Office Action Summary	Application No. 10/527,464	Applicant(s) IWATA ET AL.	
	Examiner Phuongchi Nguyen	Art Unit 2833

DETAILED ACTION

3. Claims 5 and 7-8 are rejected under 35 U.S.C. 102(b) as being anticipated by Hanazaki et al (US5739741).

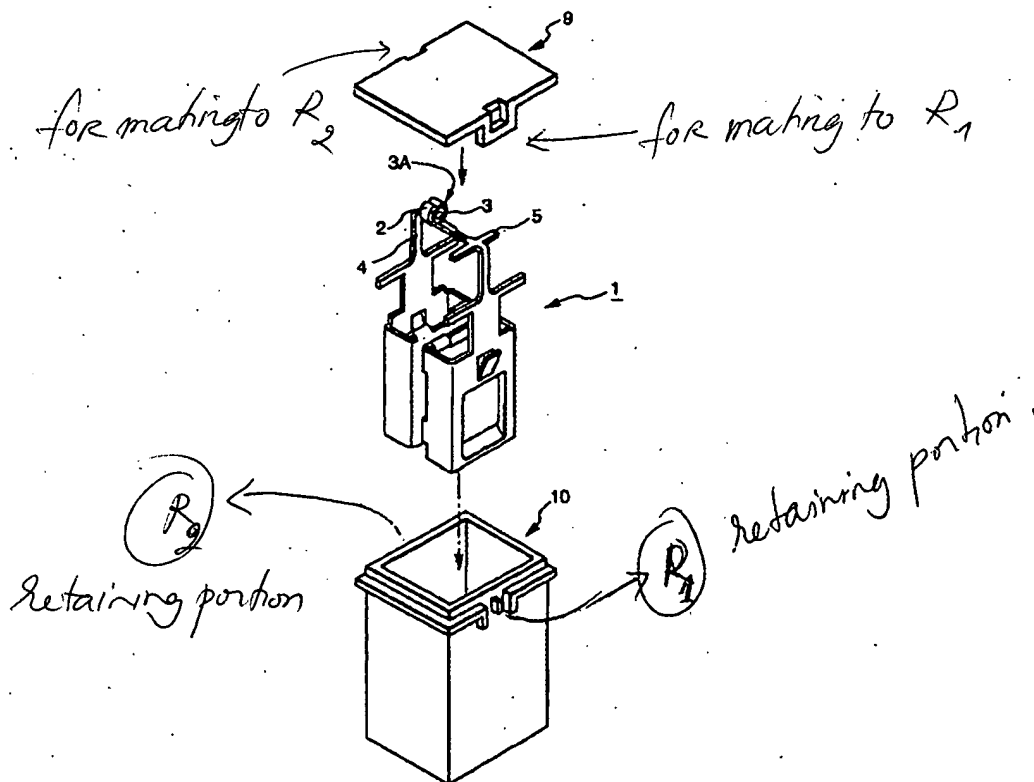
In regards to claim 5, Hanazaki et al discloses a fuse (1) comprising a fuse body (of 1); a housing (10) having a tubular shape with a rectangular cross section, which is made of an insulative resin, and receives and holds the fuse body (of 1) therein, and into which the fuse body (of 1) is inserted through an upper opening (at one end of 10) in the housing (10) so that the fuse (1) is connected to mating terminals accommodated in the housing (10) and; and a cover (9) which is made of an insulative resin, and covers the upper opening (at one end of 10) in the housing (10), wherein the housing (10) comprises a pair of retaining portion (R1, R2) is formed on a first pair of opposite side surface of the housing (attachment 1 of final office action). "Corresponding to a retaining claw of a withdrawing jig for withdrawing the housing" is not positively recited in the claim.

In regards to claims 7 and 8, Hanazaki et al discloses the fuse wherein a pair of the retaining portions (R, R) (on both sides of 10) are provided on opposite side faces of the housing

(10) so that the retaining portions (R, R) are aligned in an extending direction of a fusible portion (body of 1)/terminal portions (body of 1) of the fuse body (of 1).

4. Applicant's arguments "Hanazaki teaches a pair of retaining projections for retaining the cover, but Hanazaki fails to teach or suggest a pair of retaining portions, corresponding to a retaining claw of a withdrawing jig for withdrawing said housing..." have been fully considered but they are not persuasive; because Hanazaki does have a pair of retaining projections R1, R2 as seen in the attachment 1. Examiner gives little weight "corresponding to a retaining claw of a withdrawing jig for withdrawing said housing"; as the intended use is not treated as imparting patentability to the claim. Hanazaki teaches a pair of retaining projections R1, R2. The pair of retaining projections are capable of being used for withdrawing the housing by a corresponding to a retaining claw of a withdrawing jig. All that being claimed is a pair of retaining projections; how it is used is not a patentable distinction.

FIG. 7 PRIOR ART

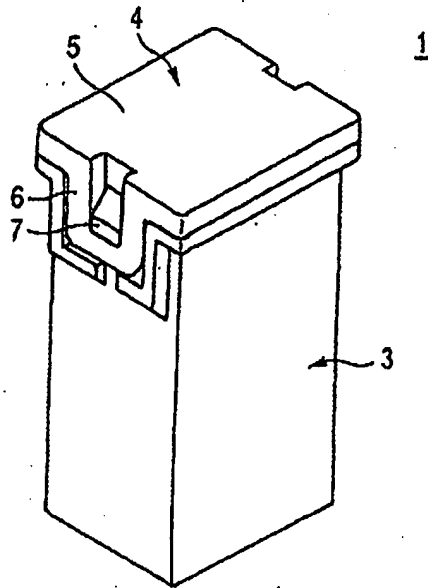
1. Applicant's amendment of February 28, 2006 is acknowledged. It is noted that claim 1 is amended. Claim 2 is canceled. New claims 5-8 are added. Figures 7 and 8 have been accepted.

approved 3/12/06 CG

FIG. 8 PRIOR ART

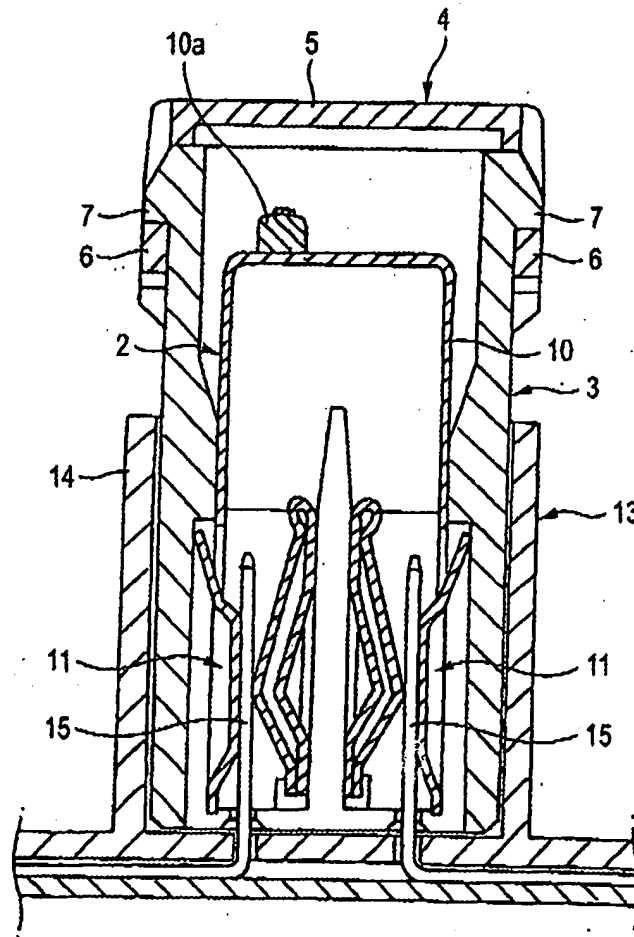
Approved 3/12/06
